Illinois Tollway Base Sheet Revisions
--

Section M	Base Sheet Drawings	
Drawing	Modification Summary	Effective: 03-01-2024
Weigh-in-Motion (ITS)-Series 1600		
M-ITS-1600	Weigh-In-Motion Cabinet and Foundation Details	
	Remove reference to Note 17 for Cisco switch and Cisco power supply	
M-ITS-1603	Weigh-In-Motion 3 Lanes

WEIGH-IN-MOTION JUNCTION BOX DETAIL

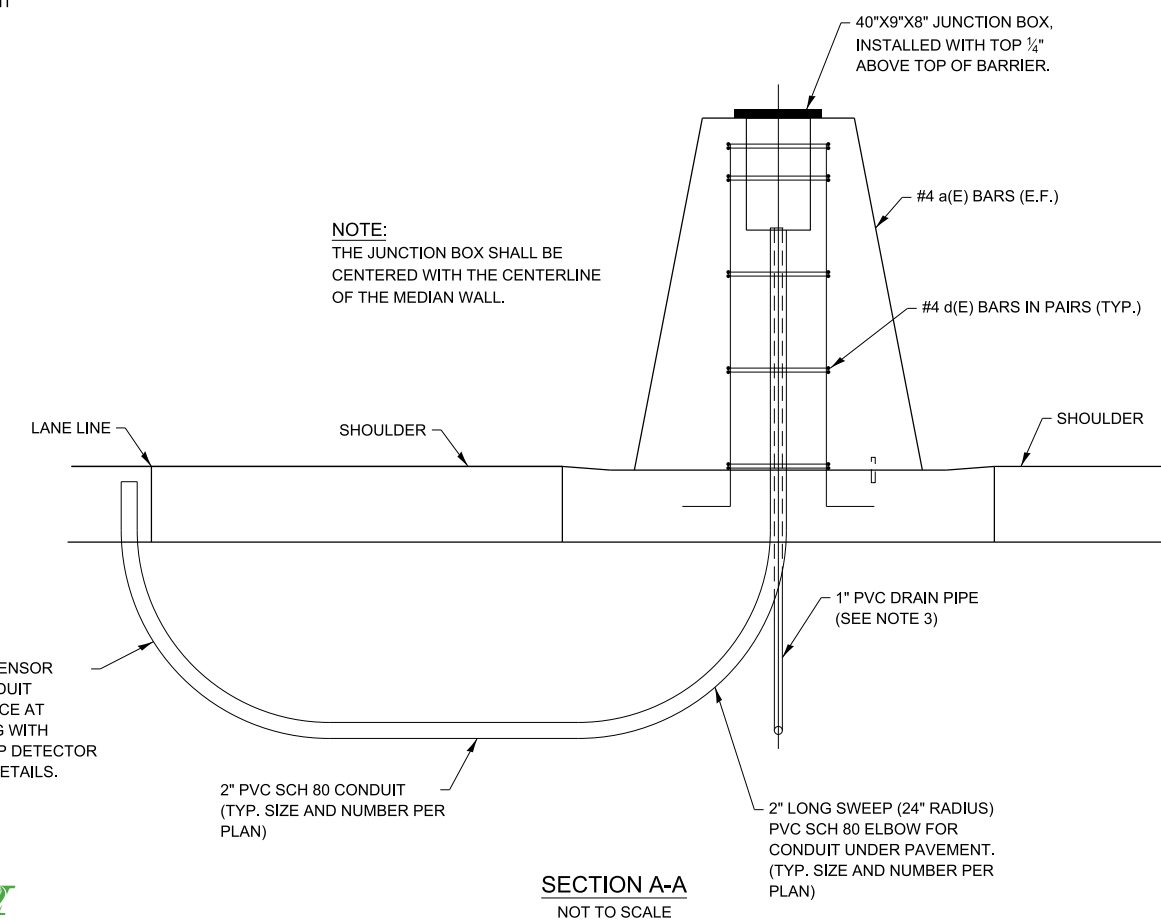
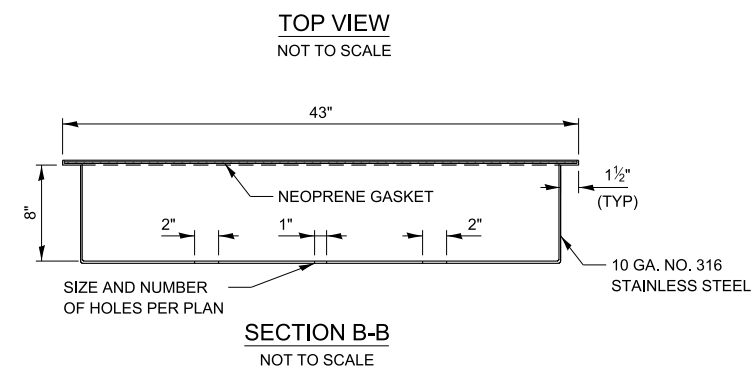
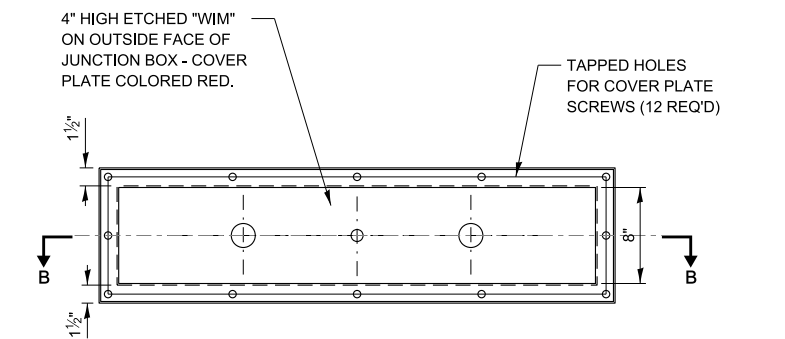
Sheet 1	Note A: Change the designation to say: Junction Box with WIM Electronics	
	Note 5: Add "straight grade obtained by diamond grinding"	
M-ITS-1606	Weigh-In-Motion Junction Box Detail	
	Plan View: added a note to say Slipformed not permitted 7 feet before the centerline of the junction box and passed 7 feet from the centerline of the junction box	
	Side View: Added detail for drain plug with a screen to prevent debris clogging the drain	
	Section B-B: Revised dimension to 8" deep	
	Section A-A: Revised dimensions of junction box to : 40"x9"x8"	
	Section A-A: Added reinforcement bars below the junction box	
	Section A-A: Added a note that the junction box shall be centered with the centerline of the median wall	
	Added Note: Slip forming the parapet or barrier is not allowed within 7-feet of the centerline of the junction box	
M-ITS-1607	Weigh-In-Motion Height Detector	
	Sensor Configuration revised to say: mounting height of each sensor at 13 feet 8 inches from the crest of the road

- NOTES:**
1. THE JUNCTION BOX SHALL BE ACCESSED FROM THE TOP OF MEDIAN BARRIER.
 2. DUCT SHALL BE CUT AND REMOVED AT JUNCTION BOX CONDUIT OPENINGS AND INSIDE BOX. ELECTRICAL CONDUITS SHALL PROTRUDE 1/4" INTO BOX.
 3. CONTRACTOR SHALL INSTALL 1" PVC PIPE TO DRAIN JUNCTION BOX TO AGGREGATE SUBGRADE. INSTALL S.S. SCREEN OVER DRAIN INSIDE JUNCTION BOX.
 4. SLIPFORMING OF BARRIER WALL PROHIBITED AT JUNCTION BOXES.

WEIGH-IN-MOTION HEIGHT DETECTOR

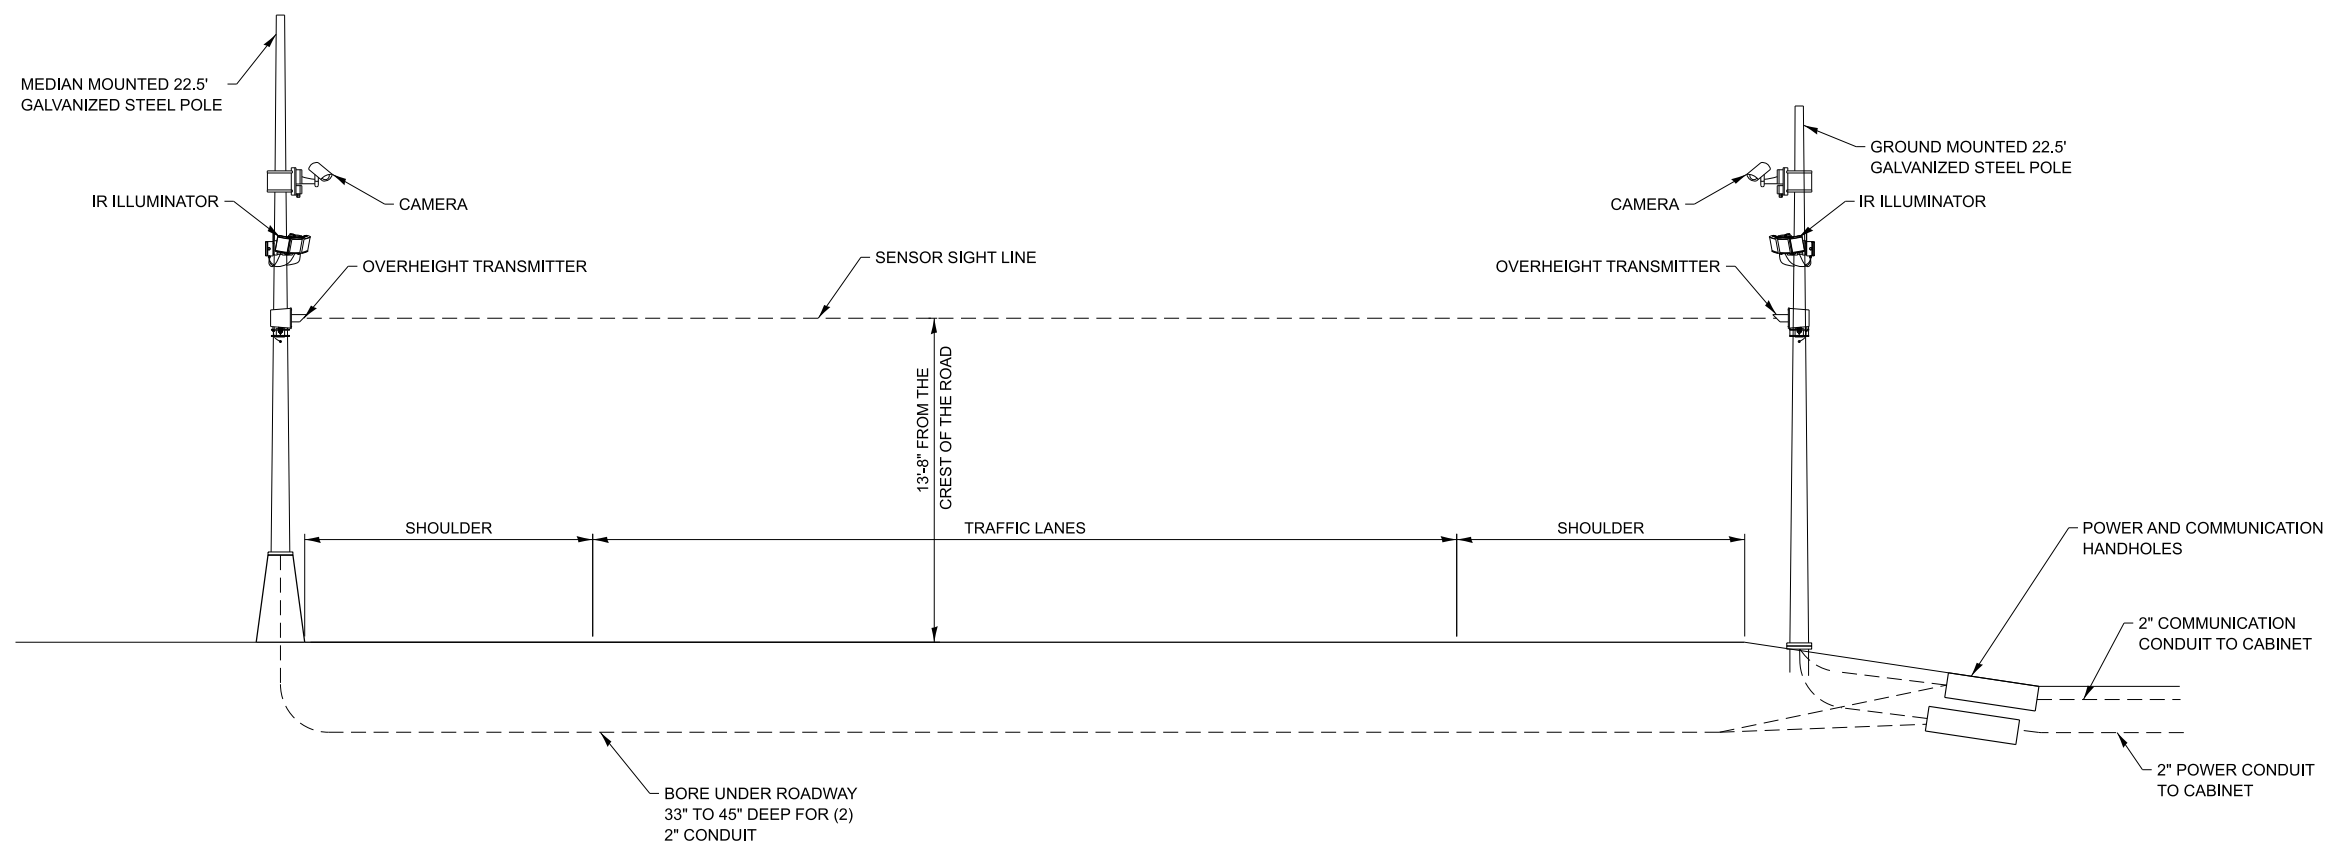
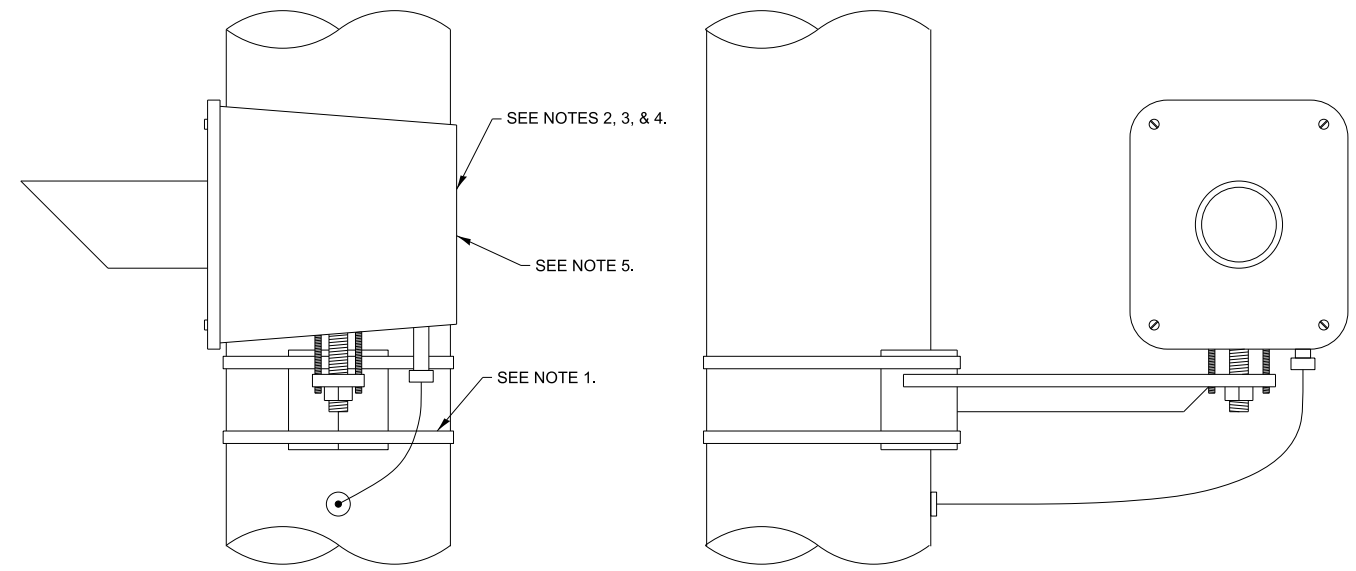
Added Note to Contractor: Submit site survey for each over height sensors mounting height to confirm mounting is 13 feet 8 inches from the crest of the road	
	Revised Note to Contractor to say: Submit Site Survey to the Engineer ...

NOTE TO THE CONTRACTOR:
SUBMIT SITE SURVEY TO THE ENGINEER FOR EACH OVER HEIGHT SENSOR MOUNTING HEIGHT TO CONFIRM THE MOUNTING HEIGHT IS 13'-8" FROM THE CREST OF THE ROAD AT THE OVER HEIGHT SENSORS LOCATION.
